SERVICE BULLETIN BOOK

1991

WMS GAMES

WILLIAMS ELECTRONIC GAMES, INC.

FLIPPERS: Improving their Action & Reliability

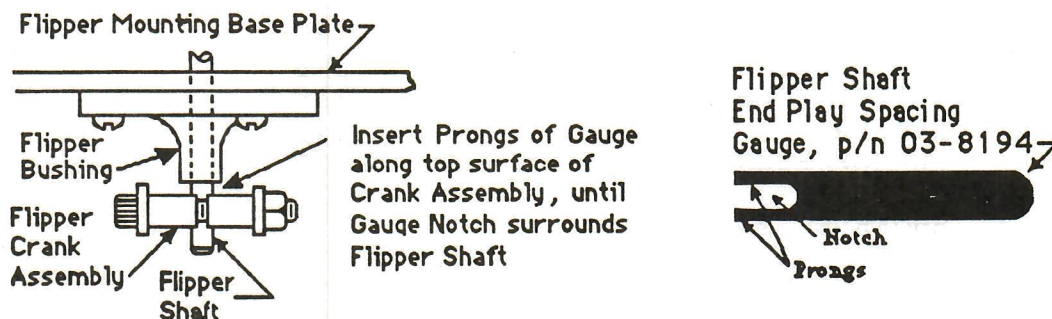
For your customers who are experiencing damaged flipper links, particularly the black or white plastic link, a gray plastic link is now available. Its slightly different design is for the purpose of preventing damage to the link near the plunger end. The part number of this new link is 03-8050-1, for ordering purposes.

We are also making this available in the form of the complete A-10656 Flipper Link Assembly (combining the plunger, gray plastic link, and the spring pin) to enable your customers to simply pull out the older Flipper Link Assembly and put in the new assembly, thereby minimizing down time.

At the same time that the Flipper Link Assembly is being replaced, we recommend the replacement of the coil plunger spring, with the latest version of the Coil Plunger Spring, part number 10-376.

In addition to these parts, a new Flipper Stop Assembly, part number A-12111, is now available. This part has a slightly longer 'post', which fits inside the coil sleeve to ensure that the plunger does not enter the coil quite as far as the earlier flipper stop (A-10821) permitted.

Installation Instructions

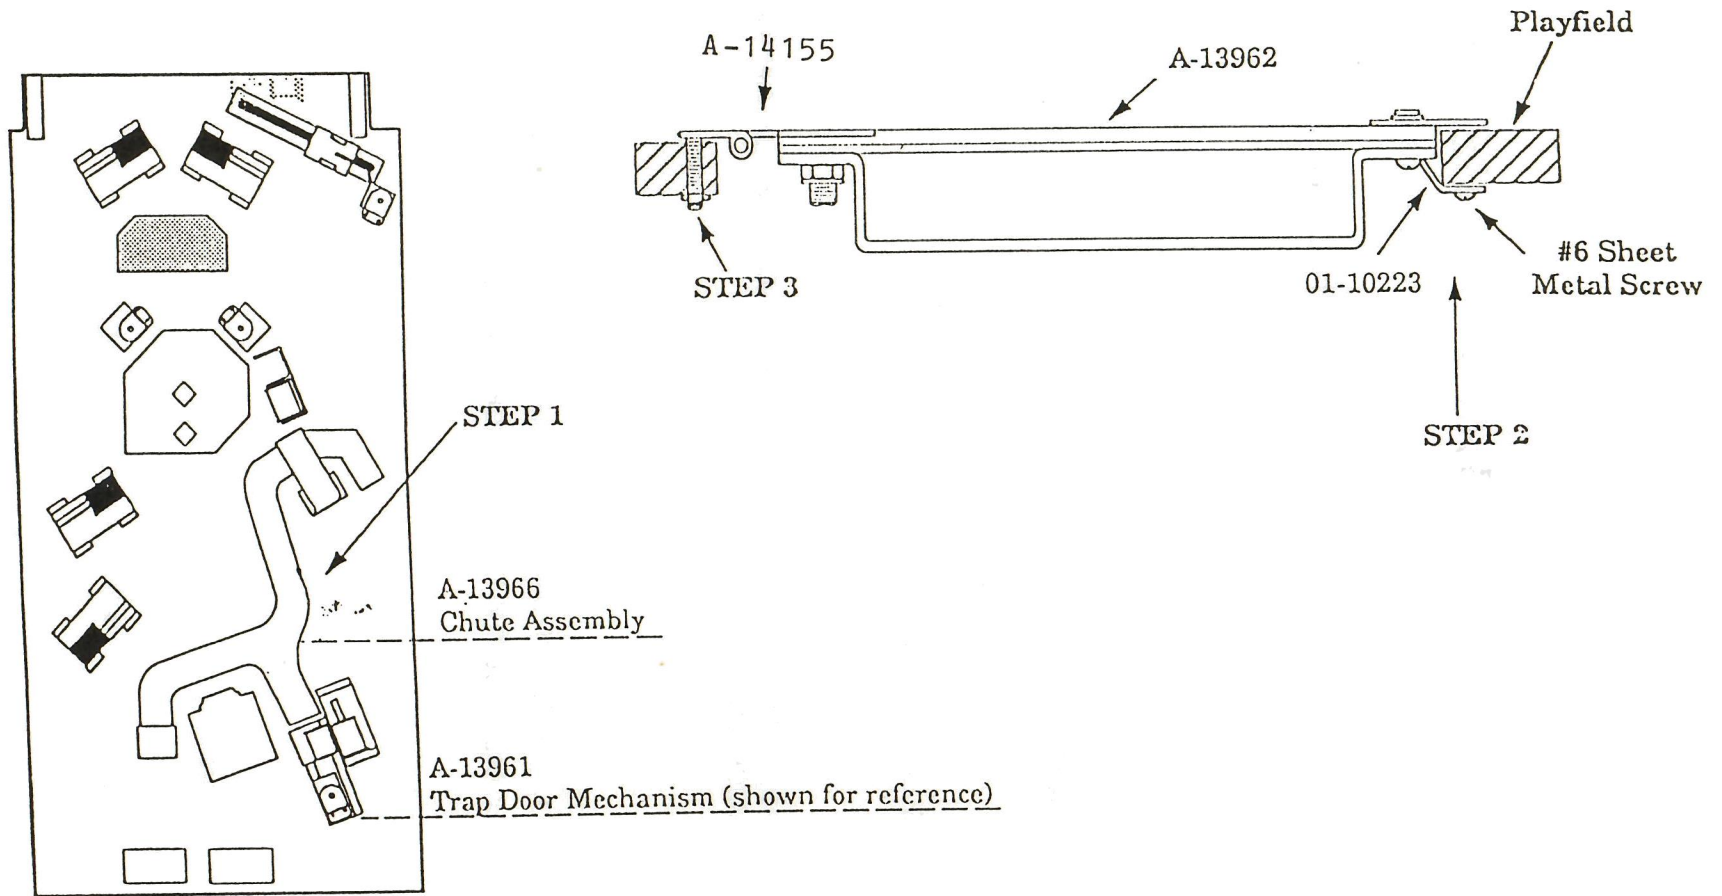
01-10223
Trap Door Stop Bracket

A-13962
Trap Door Assembly

- Step 1. From underside of playfield, remove Chute assembly (A-13966).
- Step 2. Trap Door Stop Bracket (01-10223) should be centrally installed in Trap Door opening, (using #6 sheet metal screw provided), and have its inside corner aligned with the lower playfield corner.
- Step 3. If existing Trap Door assembly is damaged, remove and replace with new assembly provided.
- Step 4. Reinstall Chute assembly.

Main Bracket Assembly

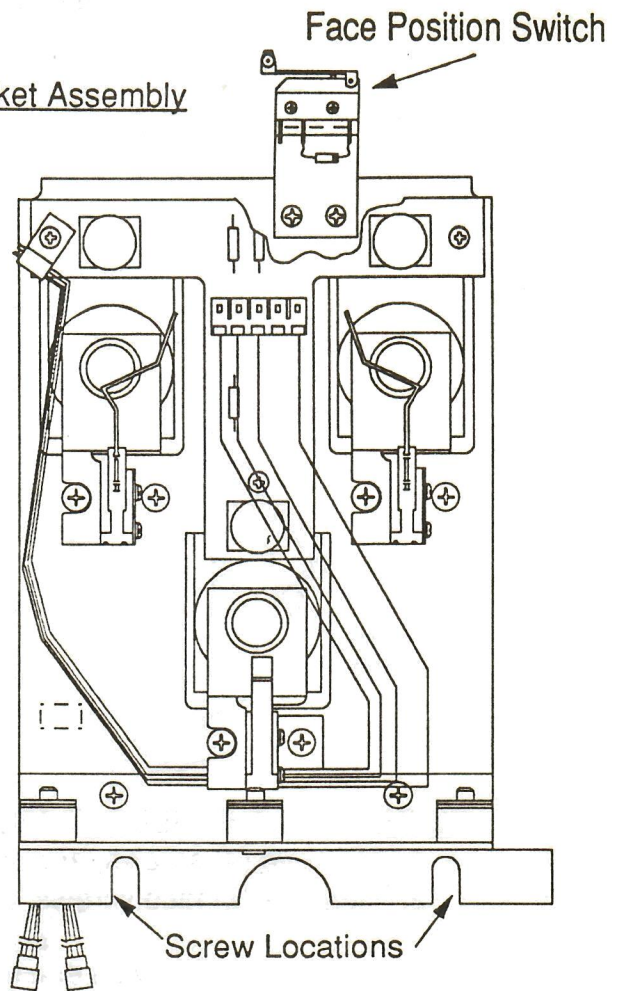
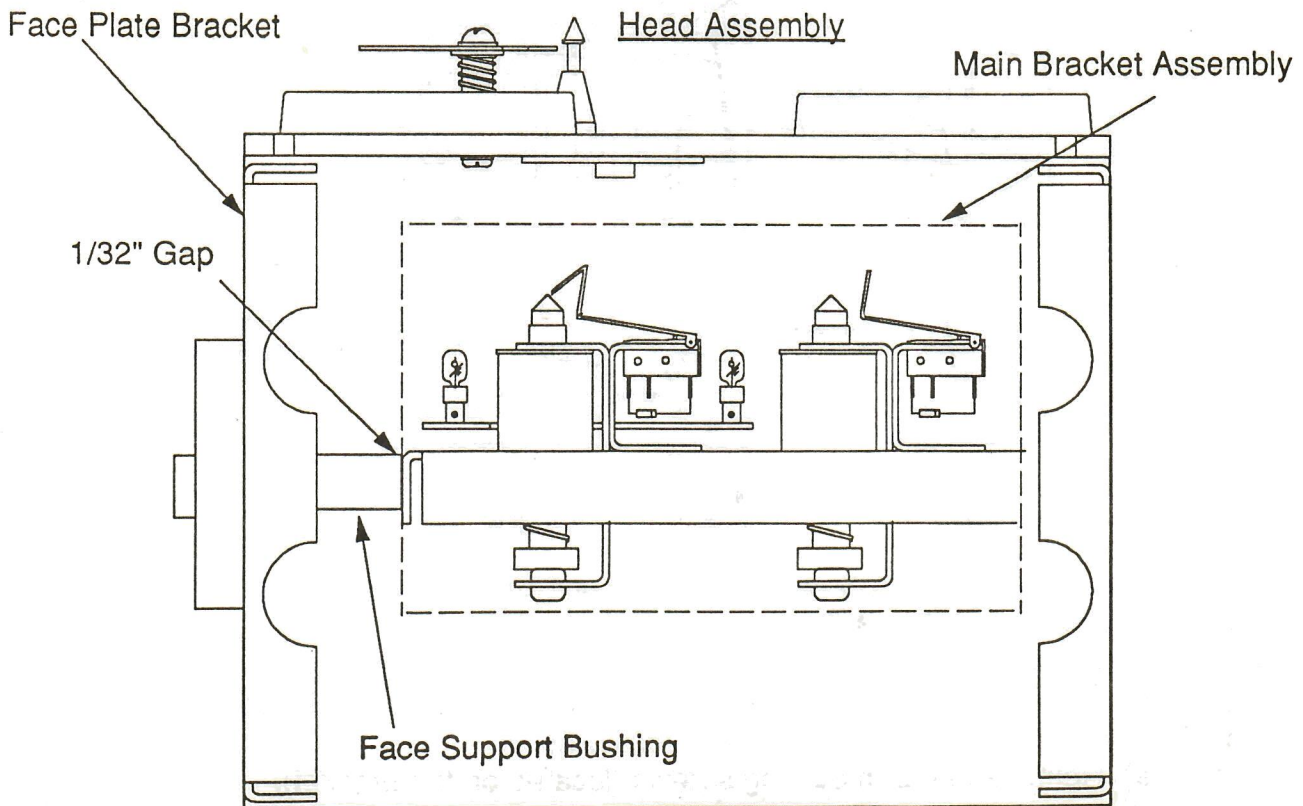
3. Put thumb and forefinger on either side of the Face Plate Bracket and push the bracket toward the back of the game.
4. Check for a 1/32" gap between the Face Support Bushing on the Head Assembly and the Main Bracket Assembly. Use a Flipper Gage to check the gap. The Flipper Gage is shipped in Cashbox.

5. Loosen (Do Not Remove) the 2 screws at the base of the Main Bracket Assembly, near the wire chute (see Top View of Main Bracket Assembly on reverse side). Use a #2 Phillips Screwdriver. Adjust the gap to 1/32".

6. Push the Main Bracket Assembly towards the back of the game until the gap between the Face Support Bushing, on the Head Assembly, and the Main Bracket Assembly is 1/32". Tighten the 2 screws and check the gap with the Flipper Gage once more.

Top View

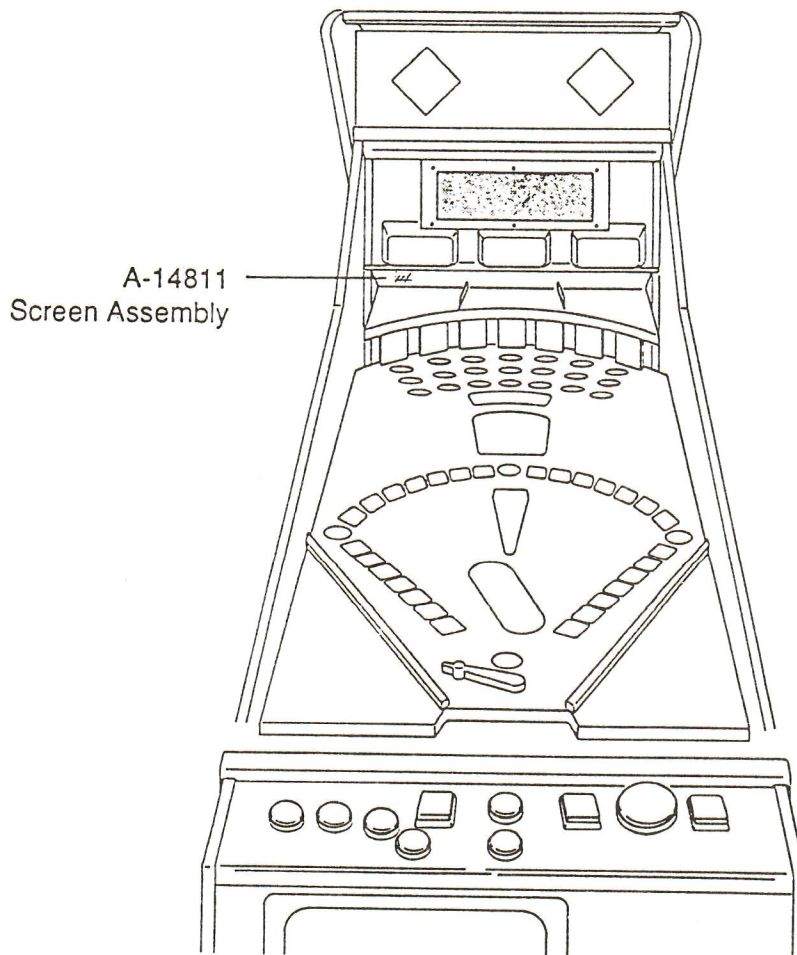
<u>PAGE</u>	<u>CHANGE</u>
2-2	A-14811 Screen Assembly replaces A-14563 Screen Assembly
2-6	Shown below Pictorially
2-35	A-14811 Screen Assembly replaces A-14563 Screen Assembly

Note: Above change started with serial number 730516 and above, please check for this information before placing order.

B-11304-4 Ramp Lifting Mechanism

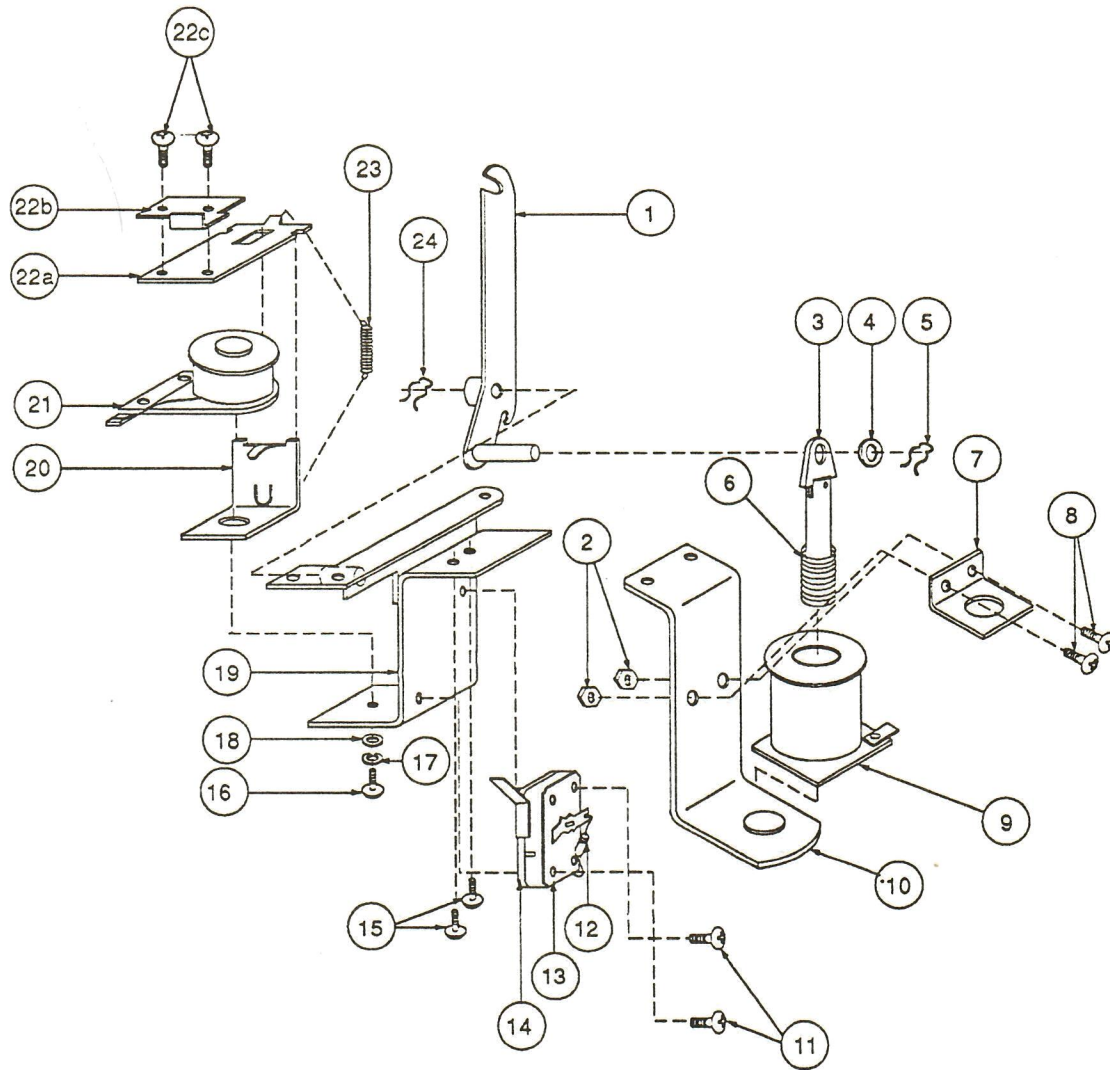
Item #21, the coil assembly, has been changed from SM1-26-600 to SM1-29-1000-DC.

The Ramp Lifting Mechanism Assembly, part number B-11304-3, has been changed to part number B-11304-4.
